# **Armadillo-400 Series Revision Information**

**Version 1.3.0**

**2012/02/29**

**Atmark Techno, Inc**

Figure 12.1. Recommended Circuit Measures for Crosstalk Noise

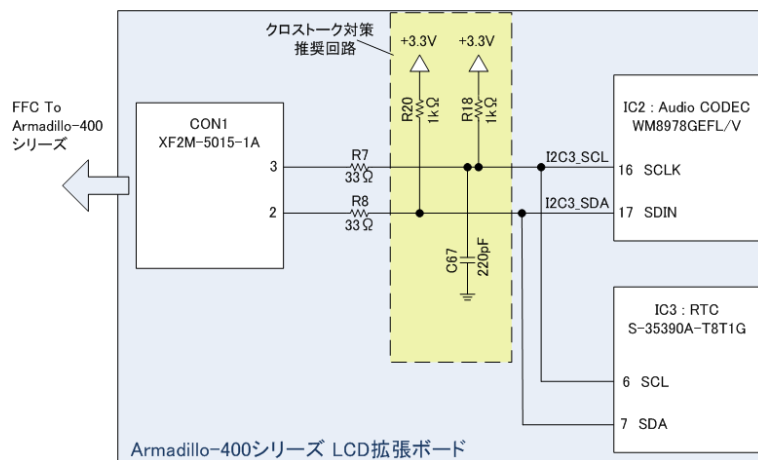
When designing an expansion board while referencing Armadillo-400 Series LCD Expansion Board product revision A, the following measures are recommended to avoid the crosstalk noise.

Target	Description
Pull-up resistor (R18) between I2C3_SCL and +3.3V	Change from 10kΩ to 1kΩ
Pull-up resistor (R20) between I2C3_SDA and +3.3V	Change from 10kΩ to 1kΩ
Between I2C3_SCL and GND	Add a 220pF condenser

Figure 12.2. Recommended Circuit Measures for ESD

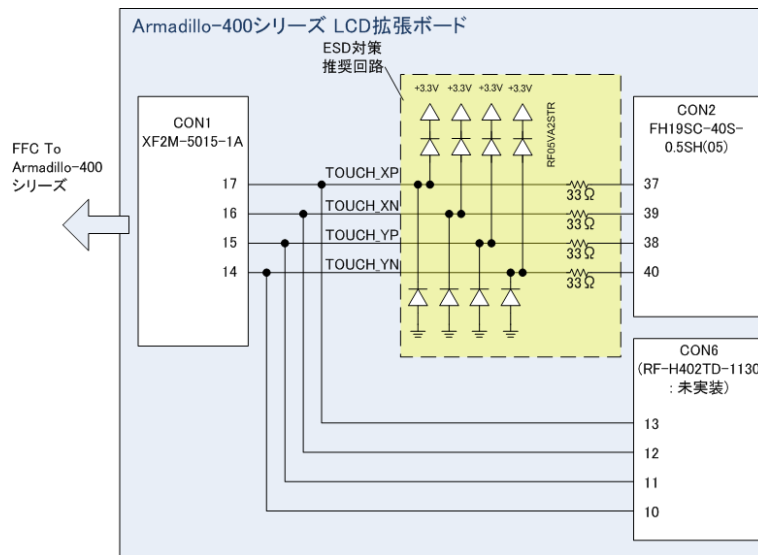
When designing an expansion board while referencing Armadillo-400 Series LCD Expansion Board product revision A, the following measures are recommended to protect against ESD. With these measures, it is possible to mitigate the chance that the i.MX257 AD input terminals used for touchscreen input will be damaged.

Target	Description
<ul style="list-style-type: none"> <li>Between TOUCH_XP and CON2 (pin 37)</li> <li>Between TOUCH_XN and CON2 (pin 39)</li> <li>Between TOUCH_YP and CON2 (pin 38)</li> <li>Between TOUCH_YN and CON2 (pin 40)</li> </ul>	<ul style="list-style-type: none"> <li>Add a dumping resistor (33Ω)</li> <li>Add input protection circuits with external components (diodes etc)</li> </ul>
